RE: S.16 Application Yeung, Stanley Tze Fung

A/SLC/190 - Departmental Comments WELT2023-0092-02 Drawing.pdf; Customer Reply Letter.pdf

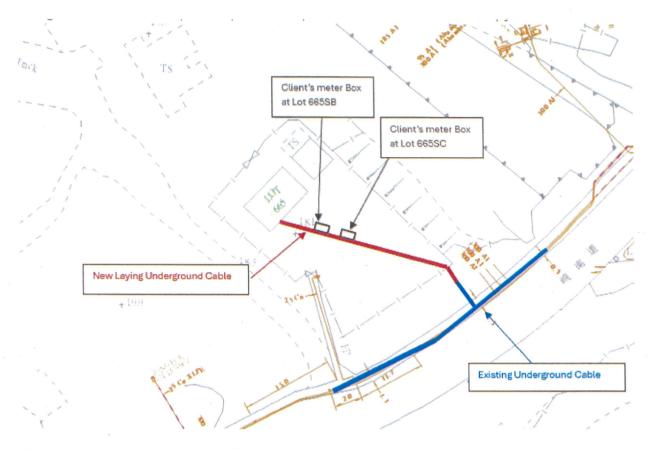
(1) Please advise the location(s), building(s0 and the main use(s) that the new electricity supply is to be provided for:

(2) Please advise whether existing cables would be involved / connected to and their locations (please provide a plan for reference).

The proposed work is excavation for extension of our existing electricity network to provide new electricity to our client located at Tong Fuk Village Lot 665 SB & Lot 665 SC, Lantau. It is required to lay new LV underground cable (Red Line) at the captioned location and make connections to our existing electricity network (Blue Line) at Tong Fuk Village, Lantau

The existing distribution network at Tong Fuk Village is illustrated below:

This is the shortest length cable would be laid to the customer's meter box from the existing underground cable network.
